Our Ref: PCB140046

27 May 2022

Response to Request for Additional Information – DA/2021/1460 - 70 Christopher Road & 799 New England Highway, Lochinvar

Figure 3: Aerial Photo of Site (Source: Nearmap; 30.05.2021)

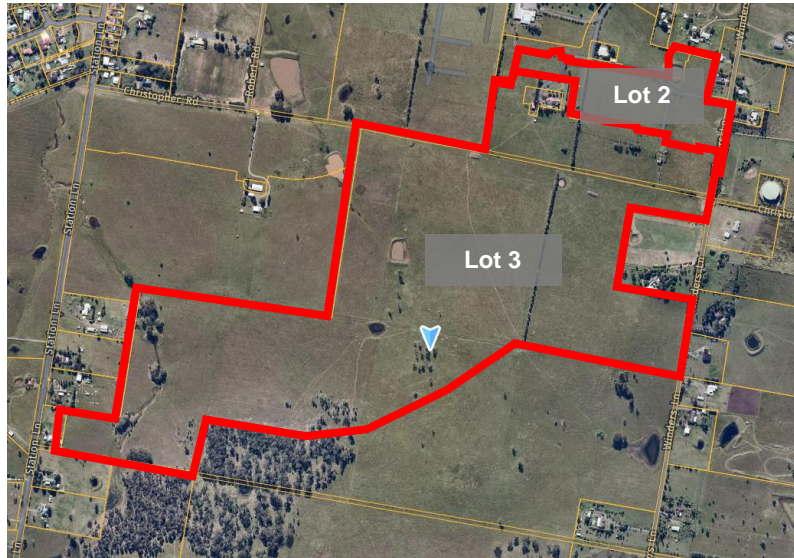
Council Note	Action / Response
<p>1. SEPP 55 (SEPP Resilience & Hazards)</p>	<p>The land has been continually used for cattle grazing between June 2017 and October 2021. This is consistent with the primary use of the land prior to June 2017. Please refer to Attachment 1 containing aerial images illustrating land use from June 2017 to October 2021. No potential contaminating activities occurred on the land between this period.</p> <p>Note works in accordance with DA17/1401 have commenced on site.</p>
<p>2. SEPP (Transport & Infrastructure) 2021</p>	<p>a. Development likely to affect an electricity transmission or distribution network.</p> <p>Noted. Please refer to the updated Concept Engineering Plans illustrating approximate location of any future substations/kiosks. Please note further detail can be provided after DA, once detailed electrical plans have been prepared in accordance with Ausgrid's requirements.</p> <p>b. Traffic generating development</p> <p>Noted. Further comment provided below.</p>
